THE  
UNIVERSITY  
OF UTAH

The enclosed materials are submitted in support of the University of Utah's application for renewal of its TRIGA Nuclear Reactor Operating License, R-126, Docket No. 50-407.

## UNIVERSITY OF UTAH TRIGA REACTOR (UUTR)

Core Configuration #18

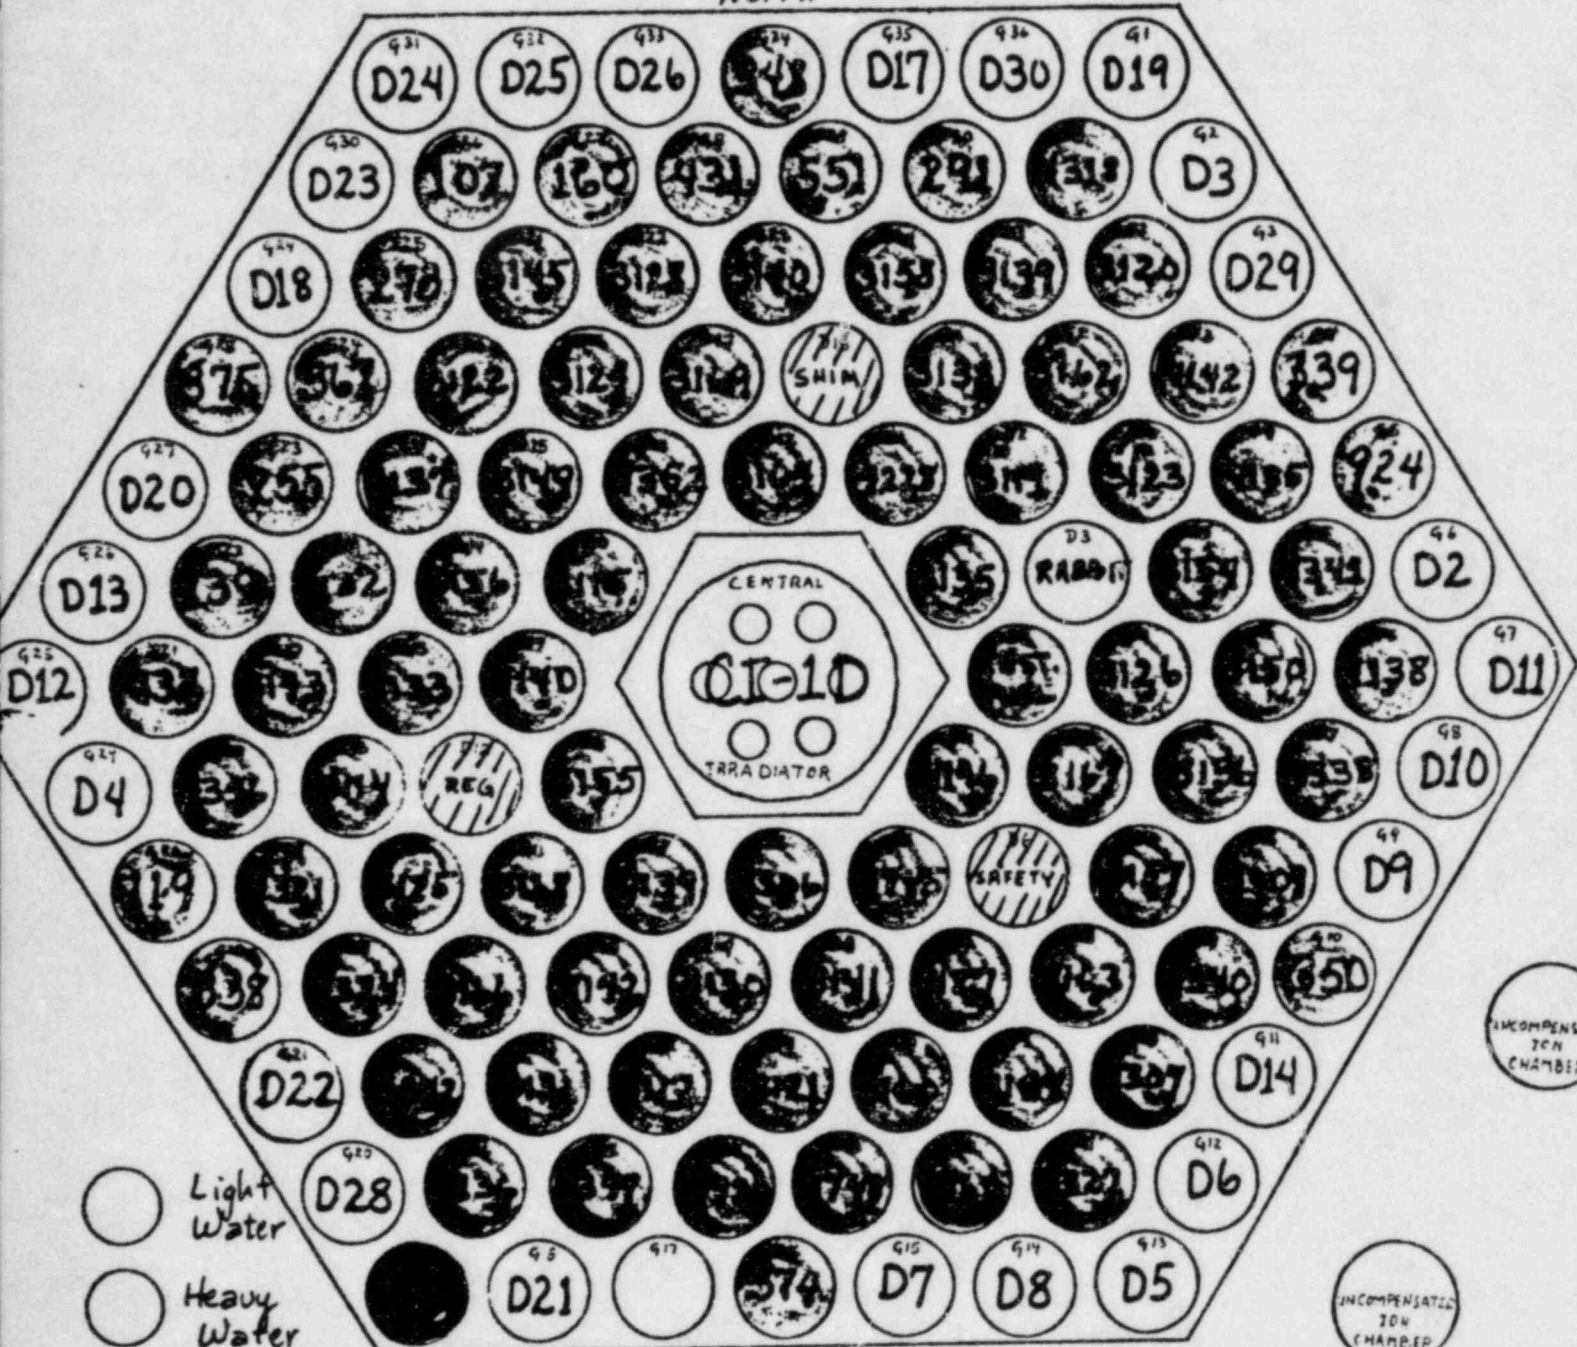
2. Provide a plan view of the current core configuration showing the number and locations of the fuel elements (differentiate between stainless-steel and aluminum elements), the control rods, the D<sub>2</sub>O reflector elements, the D<sub>2</sub>O reflectors tanks, the experimental tubes, the irradiation facilities, the neutron detectors, and the startup source. Also indicate how many and where (if any) the instrumented fuel elements (aluminum or stainless-steel) are in the current core and what type of thermocouples are used.

The Figure enclosed provides a plan view of the current core configuration. The single instrumented fuel element in position C3 is stainless steel clad. Three thermocouples (chromel-alumel) provide channel output for fuel/fuel temperature sensing.

Excess reactivity \$1.18, Safety rod \$1.76, Shim rod \$1.55, Regulating rod \$0.46, Shut down margin is \$0.83.

Reactor Tank

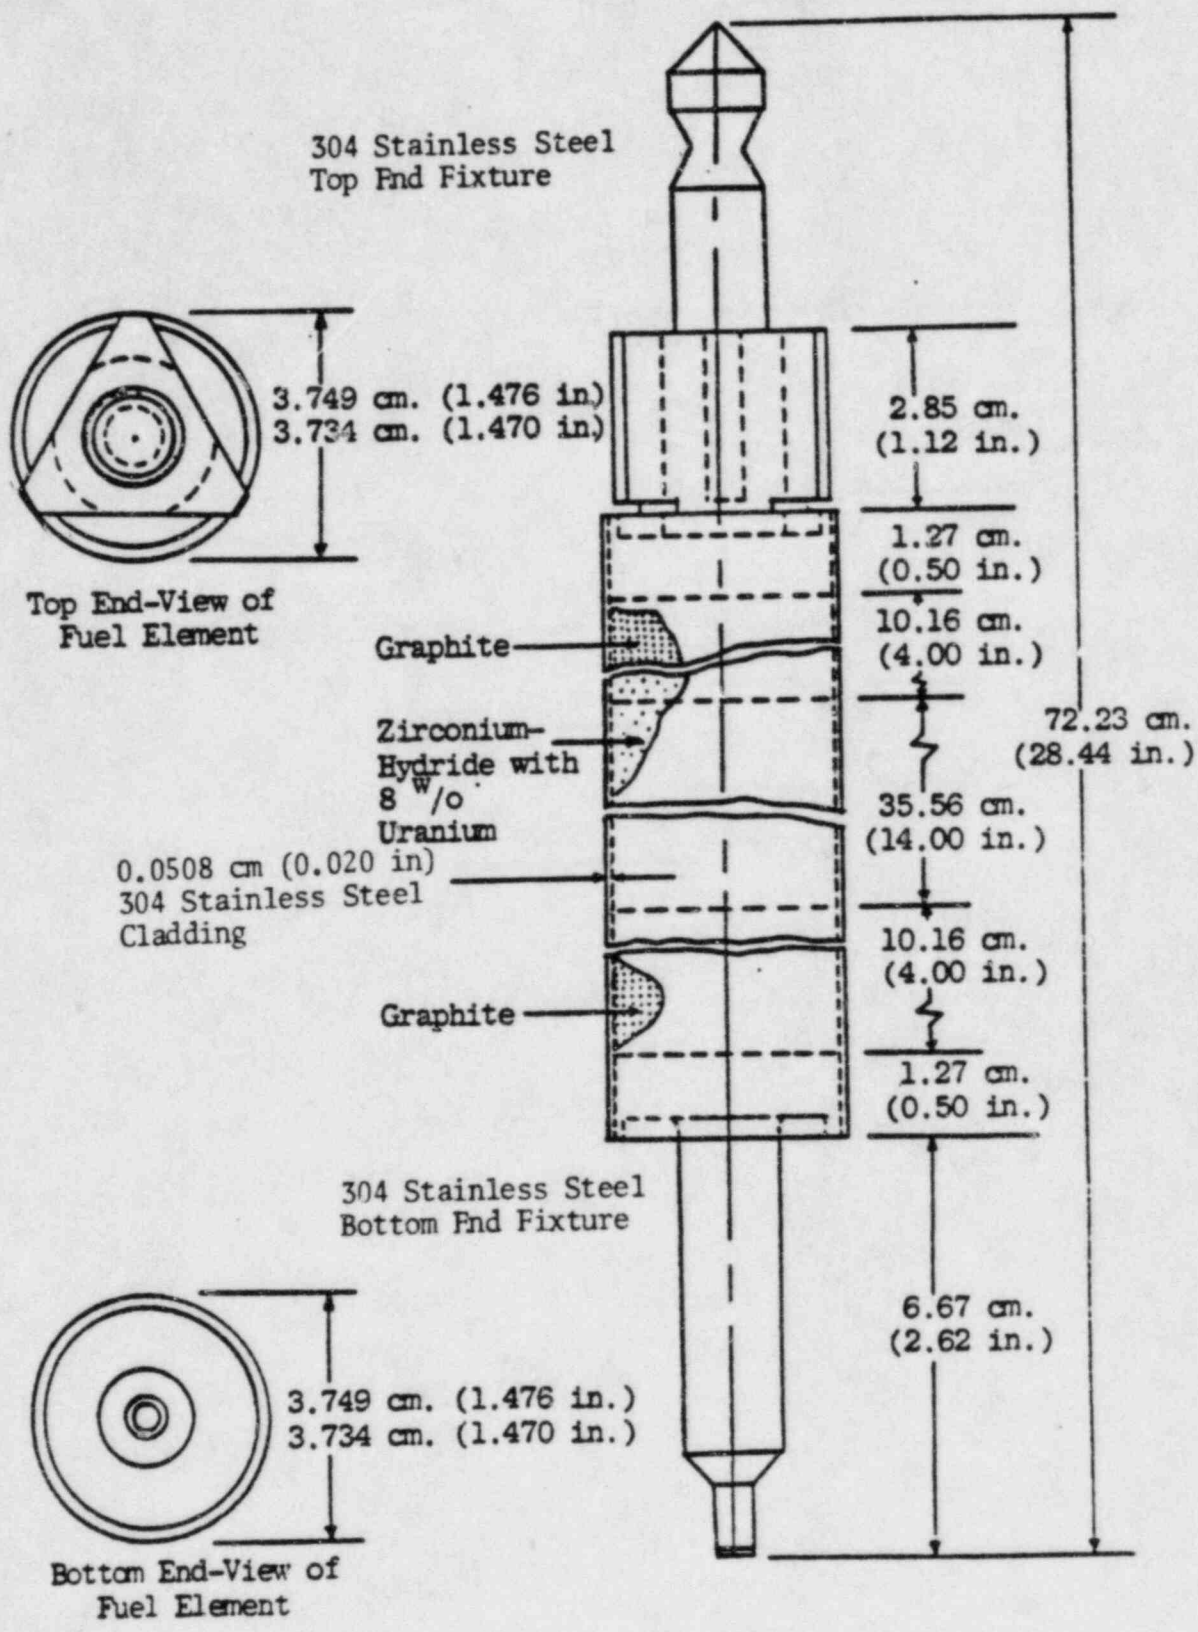
7. How many spare fuel elements are there? How many have been irradiated? Where are they stored? Describe the fuel handling tools used and fuel storage facilities at the UUTR. Give details of the current inventory of fuels in these storage areas.

There are 3 stainless clad and 45 aluminum clad fuel elements stored in the reactor tank outside the core or locked fuel storage pits. All have been irradiated (see fuel allocation table.) The fuel handling tool is the standard GA flexible cable with manual actuator which locks on the chamfered top of the element:

Stainless-Steel Clad Fuel Element

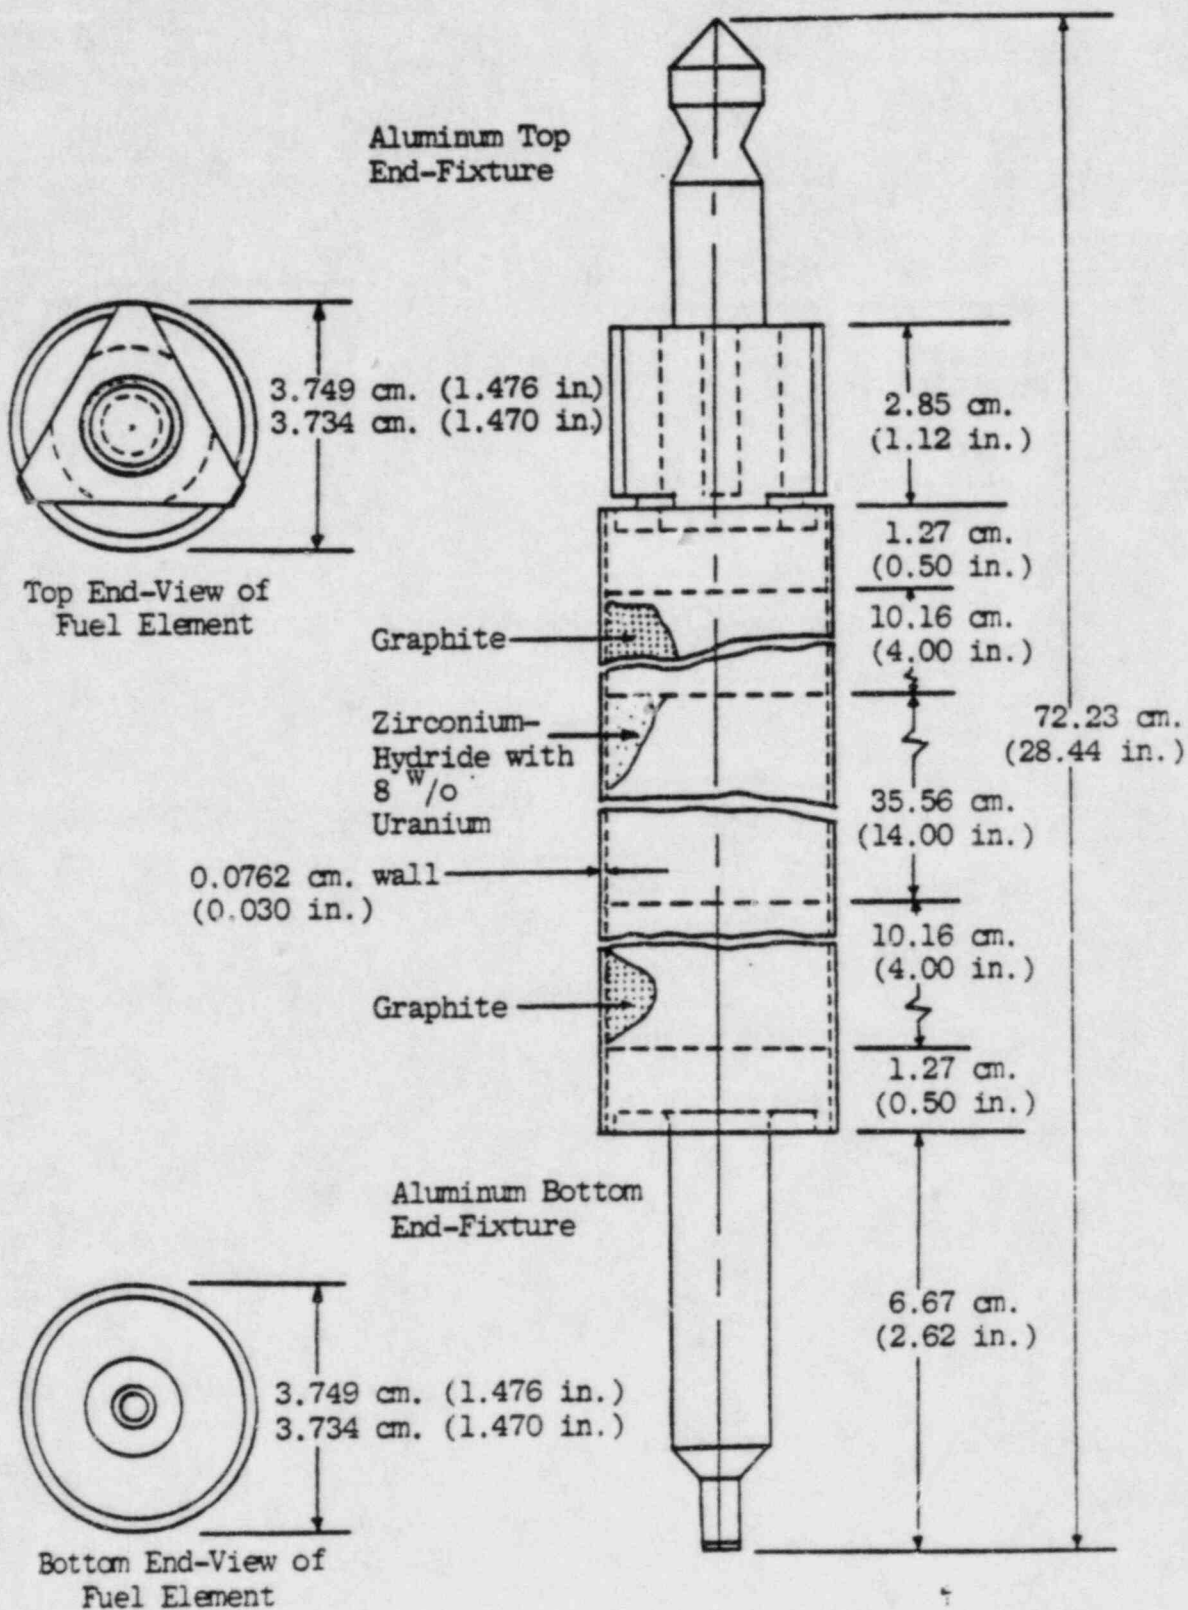
8. Provide a summary of the fuel element specifications for the stainless-steel-clad elements that are used in the UUTR. Include a schematic drawing of a stainless-steel-clad fuel element assembly.

See Attached Drawings.

CONTROL ROD MECHANISM  
UNIVERSITY OF UTAH TRIGA REACTOR  
NUCLEAR ENGINEERING LABORATORY

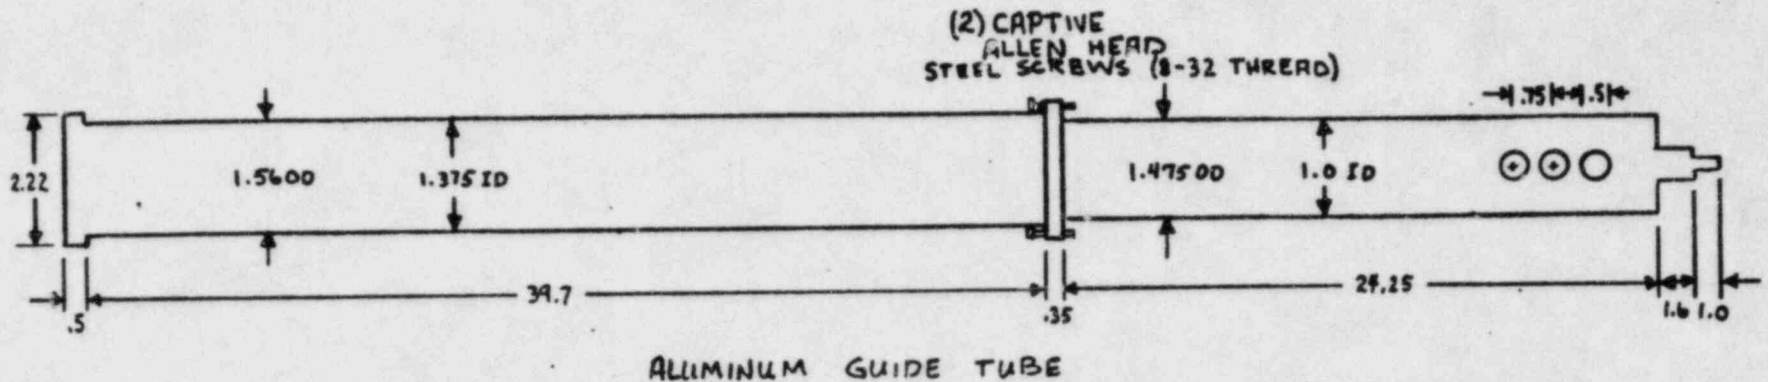
11. What is the type and form of neutron poison contained in the control rods? What are the dimensions and what is the vertical travel length of the control rods?

See figure attached. Neutron poison in control rod is boron-carbide, vertical rod travel is 15 inches.

PNEUMATIC RABBIT  
UNIVERSITY OF UTAH TRIGA REACTOR  
NUCLEAR ENGINEERING LABORATORY

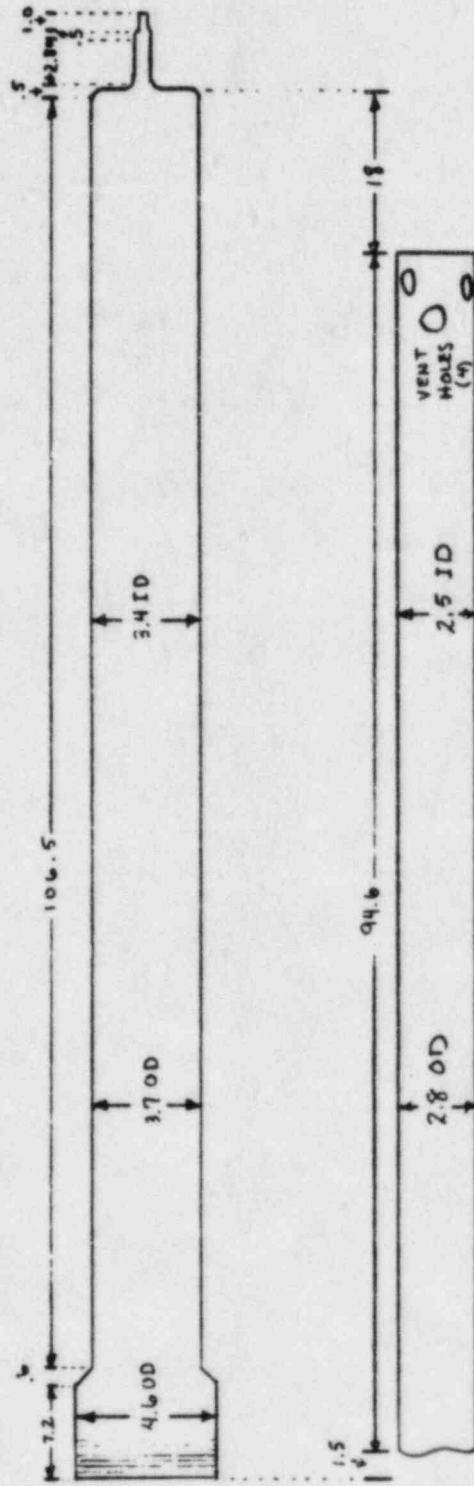
22. What restrictions are placed on the samples that are irradiated in the pneumatic transfer system? Describe the pneumatic transfer irradiation facility (materials of construction, dimensions, terminals, propulsion method, and controls).

All samples irradiated in the pneumatic transfer system must satisfy technical specification 3.6 and are always encapsulated and sealed in a polyethylene sample vial and then inserted in a polyethylene pneumatic transport vial (see figure). A detailed figure of the pneumatic rabbit is enclosed. All construction materials are aluminum except the damper spring which is stainless steel. Air is used to propel the sample in and out of the core. The control system for insertion and removal is electronic employing a time and air-value relay system. Fissile samples are not permitted to be irradiated in the pneumatic system under the provisions of the Nuclear Engineering Laboratory Operations Manual for the UUTR.

Figure 4.6.1 Ventilation System

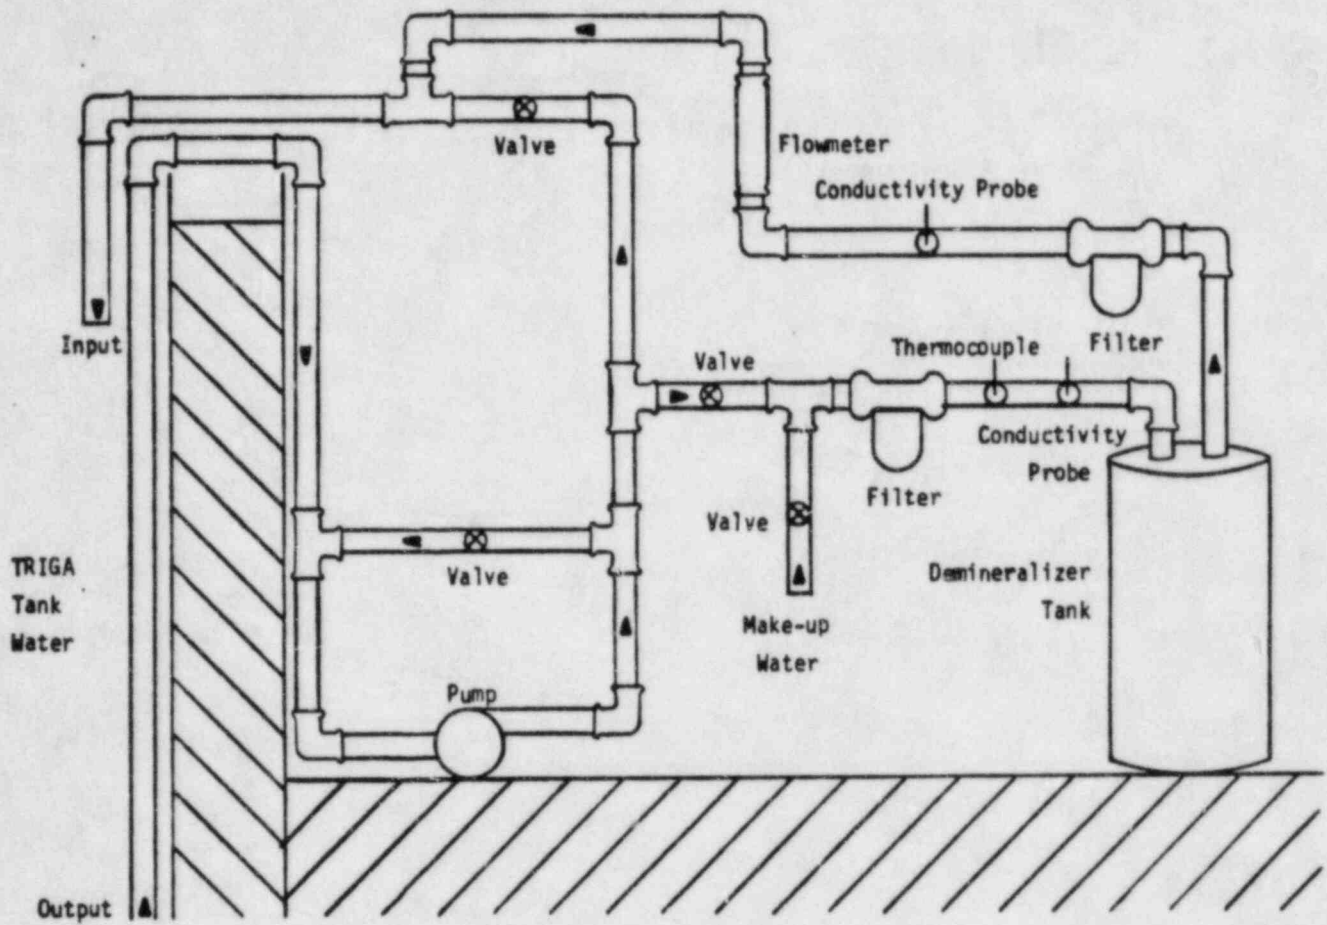
23. How is the  $^{41}\text{Ar}$  from the irradiation of air in the pneumatic system handled.

Exhaust air from the pneumatic system is vented to the reactor room exhaust system and is monitored by the ventilation system detector. See figure for ventilation system schematic.

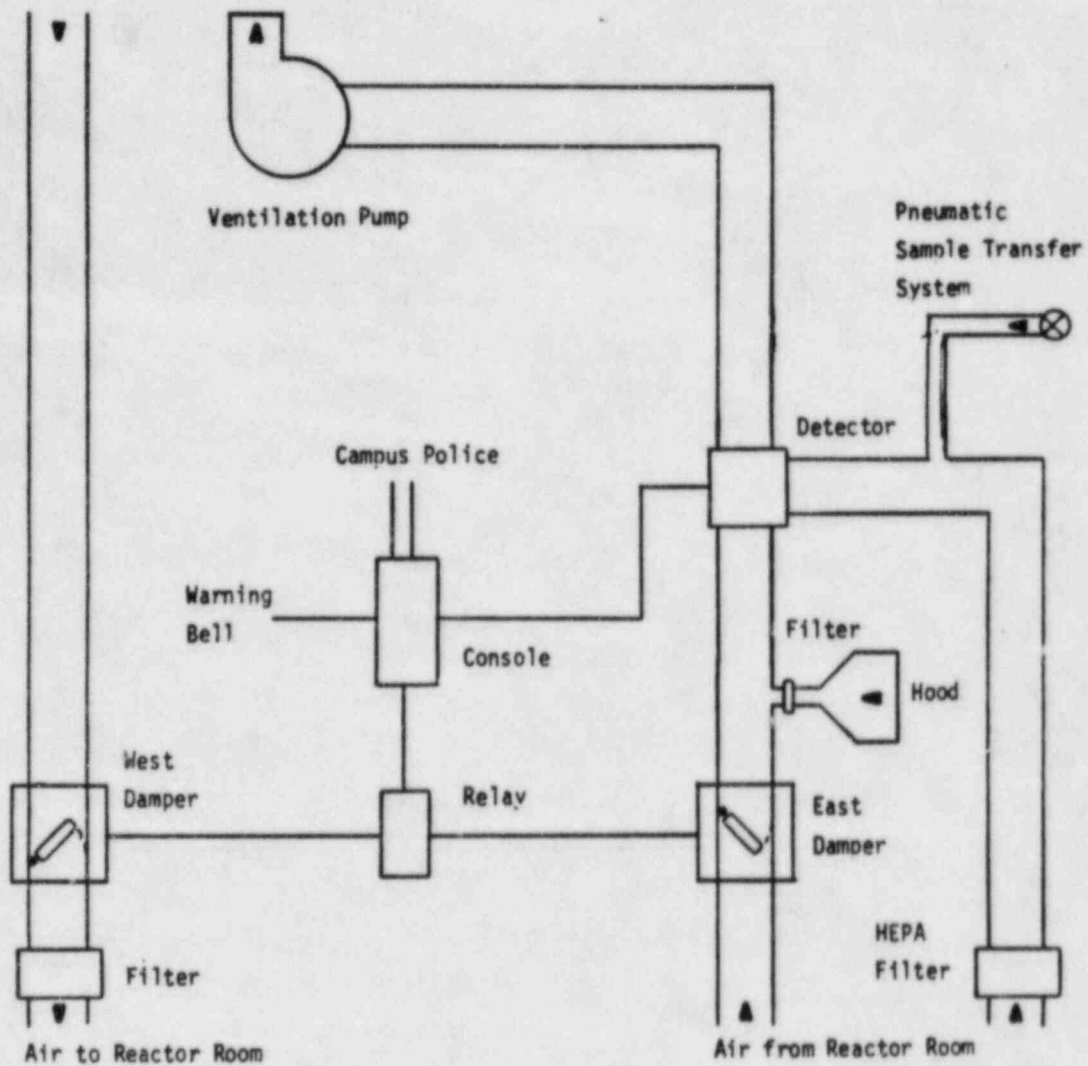
26. Provide a schematic drawing of the primary coolant circulation loop and the primary coolant purification system. What are the coolant flow rates through the circulation loop and the purification loop?

Average primary coolant flow through the main circulation loop is 50 gal per minute and 4 gal per minute for the purification loop. See figure for schematic.
